CNPA Planning Committee

2012/0342/DET
Ballinluig
Tomintoul Road
Grantown-on-Spey

Proposal: Demolition of existing mono pitch roof extension, pitched roof extension & porch and erection of new extensions & internal alterations

Photomontage of current proposal

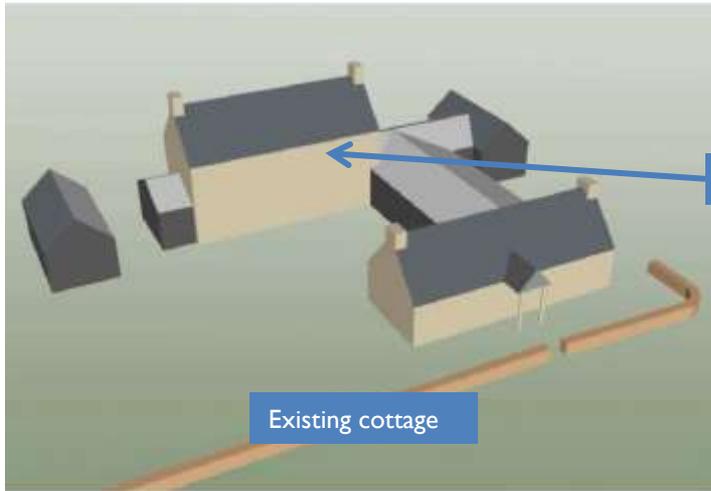
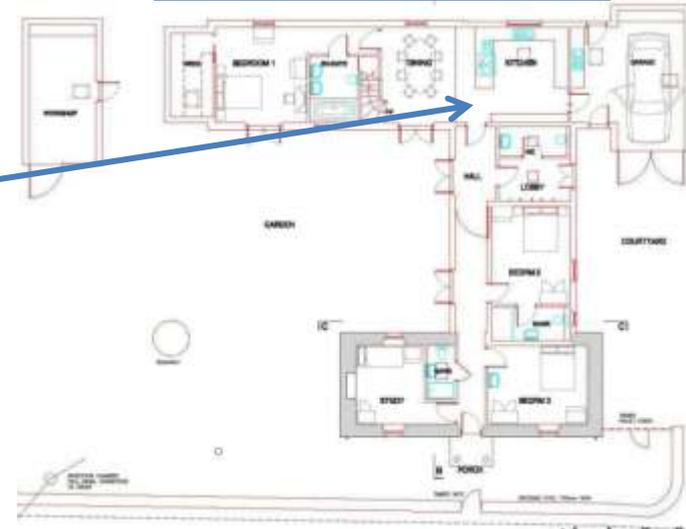
COMMENTS: While recognising that this latest application leaves the road frontage of the cottage largely unaltered the CNPA would question whether the proposal could be considered to truly accord with Policy 24 of the CNP Local Plan which requires that house extensions respect the massing and proportions of the existing dwelling.
